**GW-048**

**General  
Correspondence**

Re: Work Plan for Provision 16  
Renewal Discharge Permit, GW-048  
Denton Gas Plant  
Lea County, New Mexico

**From:** Lowe, Leonard, EMNRD [mailto:[Leonard.Lowe@state.nm.us](mailto:Leonard.Lowe@state.nm.us)]  
**Sent:** Monday, October 05, 2009 10:31 AM  
**To:** Bob Stewart  
**Cc:** Elena Hofmann  
**Subject:** GW-048, Davis Denton GP

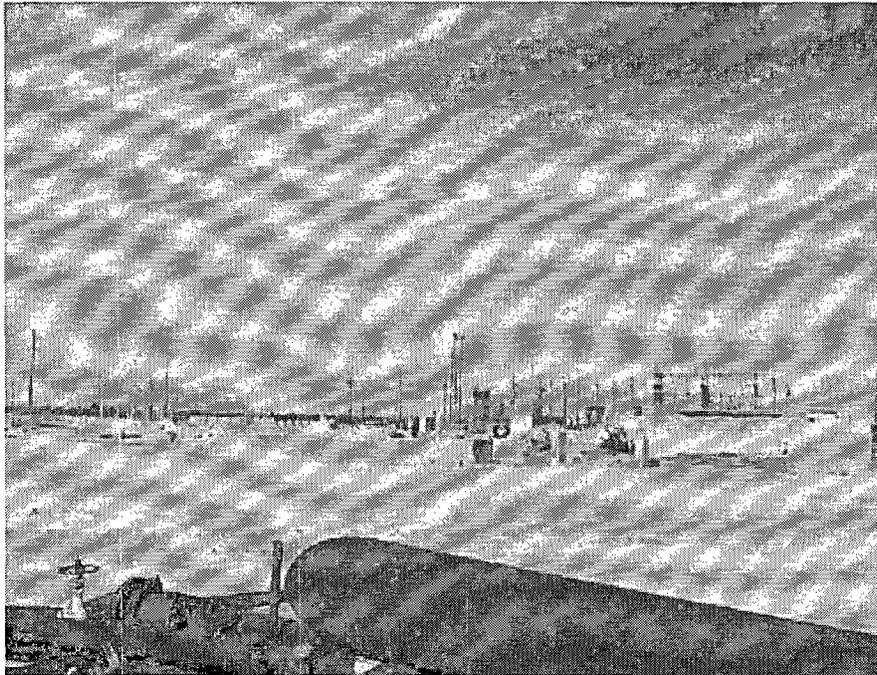
1. SECTION 5: 6<sup>th</sup> paragraph states, "An Idle ammonia plant and an idle/inoperative refrigerated gas plant process unit..." Is this statement referring to the concrete slabs located on the SW side of the Davis Denton facility (see photo)?

1. Yes, the concrete slabs that you show via photo represent where the ammonia plant use to be.
2. The description noted in Section 7 was incorrect. There is no unlined pit where the facility pumps excess rainwater. Please replace Section 7 with the revised Section 7 attached.
